# **28F016SV**

## **SPECIFICATION UPDATE**

Release Date: February 1997

Order Number 297554-009

### Queueable Operation Delay after Power-Up and Exit from Sleep, Power-Down, or Reset

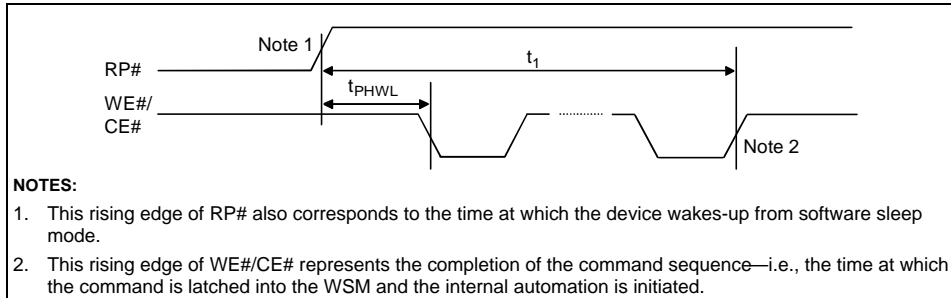
**PROBLEM:** With the program/erase voltage ( $V_{PP}$ ) at 5V, the internal  $V_{PP}$  detector may not stabilize for up to 5  $\mu$ s (illustrated by  $t_1$  in the figure, *Queueable Operation Delay after Power-Up and Exit from Sleep, Power-Down, or Reset*, which follows) after RP# transitions inactive (high). This causes an invalid  $V_{PP}$  Level bit indication when reading the Block Status Registers and termination of program, erase or lock block operations due to invalid device  $V_{PP}$  error detection. Affected operations include Word/Byte Write (40H/10H), Single Block Erase (20H), Erase All Unlocked Blocks (A7H), Two-Byte Write (FBH), Page Buffer Write to Flash (0CH), and Lock Block (77H).

**WORKAROUND:** Upon reset, power-up, or wake-up from software sleep or hardware deep power-down, allow 5  $\mu$ s ( $t_1$ ) before initiating a Write/Erase command (as listed earlier) or reading the  $V_{PP}$  Level bit of the Block Status Registers (BSR.1). The figure below illustrates this timing requirement ( $t_1$ ) in more detail.

**Example System Software Flowchart That Will Not Encounter “Completion with Command Error or Invalid Device Operation” Condition**

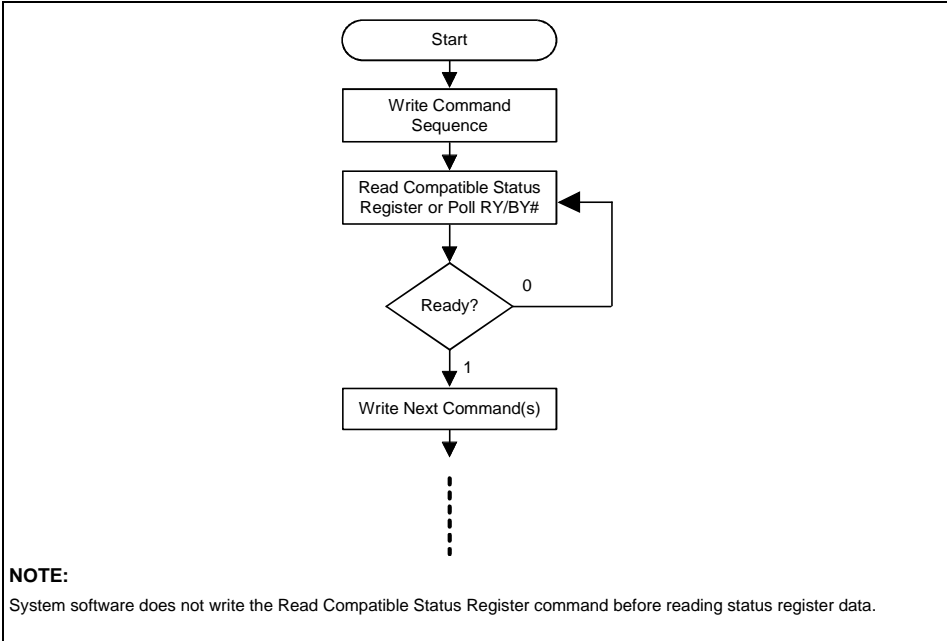
**Option 1: Polling for “Ready” Indication**

Systems that poll the RY/BY# pin or WSMS bit (CSR.7) for “Ready” indication before writing another command to the device will not encounter this errata. This is illustrated in the *Example System Software Flowchart, etc.* figure below, and flowcharts 11-1 and 11-2 (without erase suspend) of the *16-Mbit Flash Product Family User’s Manual*.

**Timing Waveform Showing Specification Ranges That Will Not Cause the “Completion with Command Error or Invalid Device Operation” Condition**

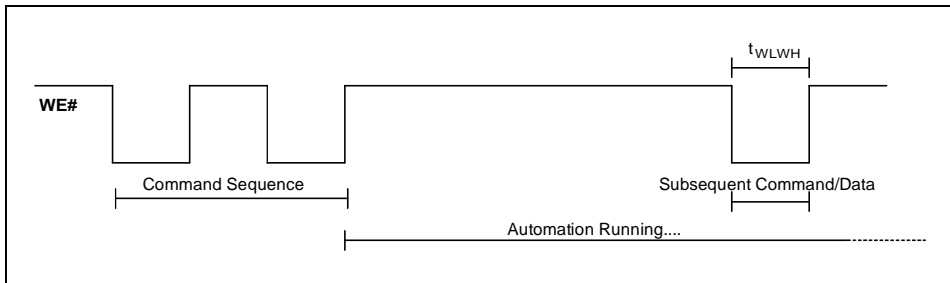
**Option 2: WE# and CE# Pulse Width Restrictions**

For WE#-Controlled Write Operations, a WE# pulse width defined by the ranges of parameter  $t_{WLWH}$  in the table below, will result in a system that does not exhibit this errata (note: timings are also bounded by specifications in the device datasheet). When performing CE#-Controlled Write Operations, this restriction equally applies to the CE# pulse width ( $t_{ELEH}$ ).

V <sub>CC</sub> Supply Voltage	$t_{WLWH}$	$t_{ELEH}$
5V	<75 ns	<75 ns
3.3V	<100 ns	<100 ns

**Example System Software Flowchart That Will Not Encounter  
“Invalid Device Operation” Condition through Checking Queue Status  
(ONLY VALID FOR COMPONENTS WITH DEVICE REVISION CODE 02H, 03H and 04H)**

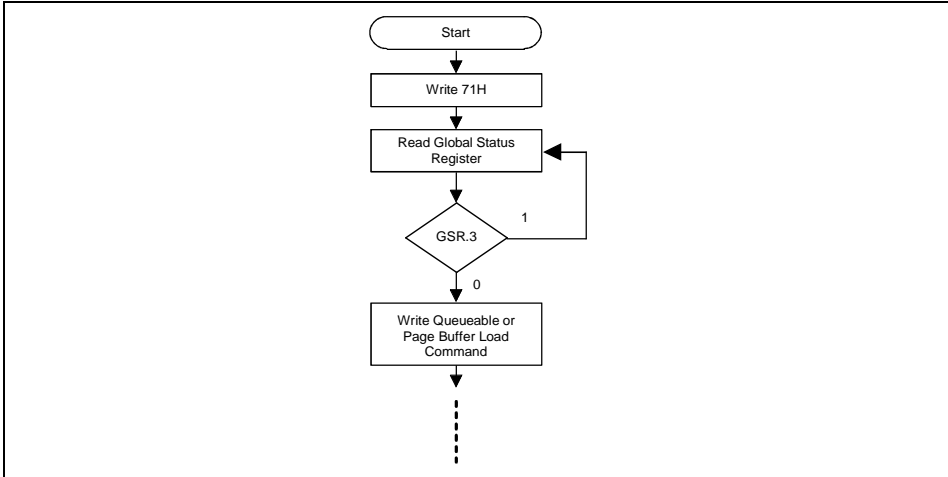
**Option 3: Checking Command Queue Availability before Writing to a Page Buffer**  
(Applicable **only** to components with Device Revision Codes 02H, 03H and 04H)

Before writing Sequential (E0H) or Single (74H) Load to Page Buffer command sequences, poll the QS bit (GSR.3) to determine queue availability. If the queue is available, system software can write a Page Buffer Load command sequence to the device, as shown in the *Example System Software Flowchart, etc.* figure below. This is analogous to the procedure outlined in Chapter 11 of the *16-Mbit Flash Product Family User's Manual* for issuing queueable commands.

**Erase Suspend to Read Array with Compatible Status Register**

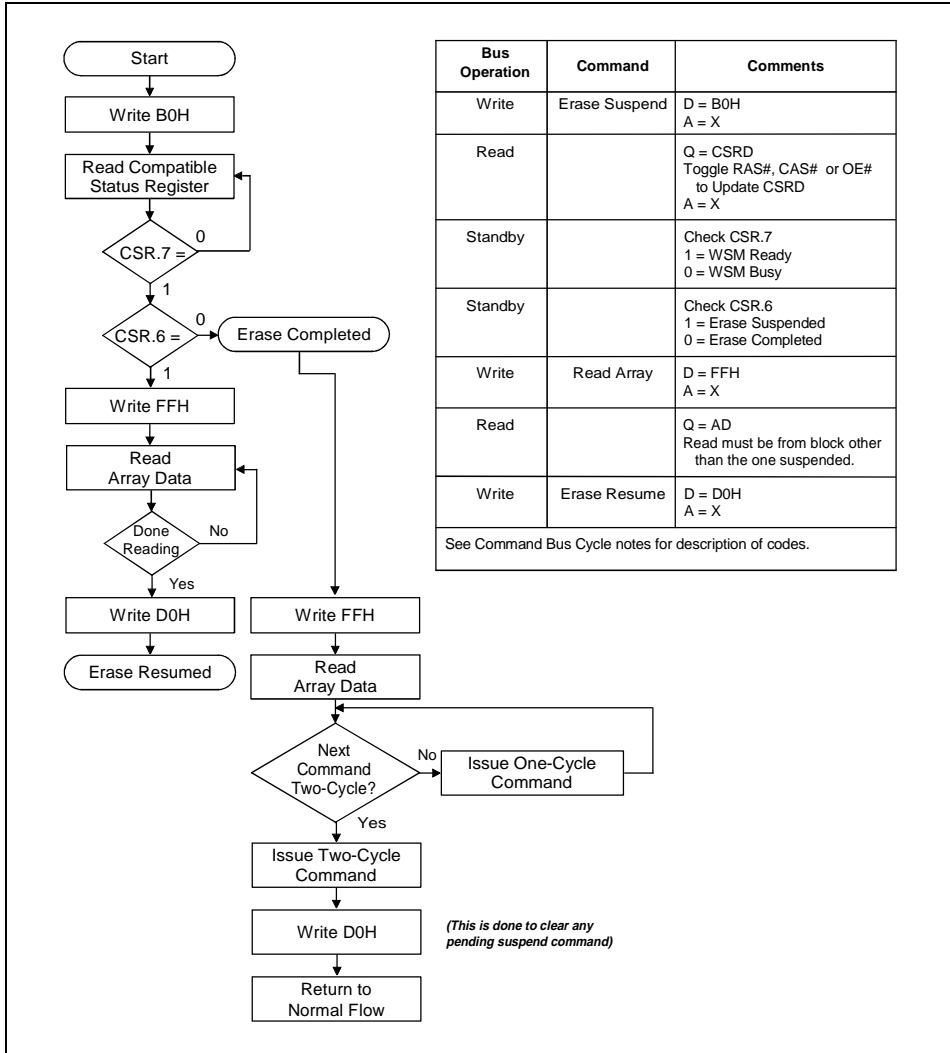
**PROBLEM:** If an Erase Suspend command is issued late in the Erase algorithm, it will not be recognized by 28F016SV components listed in the Affected Devices section, and erase will complete. This Erase Suspend command will **not** be discarded.

**WORKAROUND:** A software workaround to this erratum inserts a redundant Resume command (DOH) immediately following any Two-Cycle Command (Word Write, Block Erase, Lock Block, or Upload Status Bits) in the Erase Suspend flowcharts. Modified Erase Suspend to Read Array flowcharts (Figures 11-3 and 11-12 of *the 16-Mbit Flash Memory Product Family User's Manual*) detailing this workaround are shown in the following figures, *Erase Suspend to Read Array with Compatible Status Register* and *Erase Suspend to Read Array with Extended Status Register*. This erratum results in the *Erase Suspend with Compatible Status Register* flowchart being incompatible with the 28F008SA *Erase Suspend* flowchart.
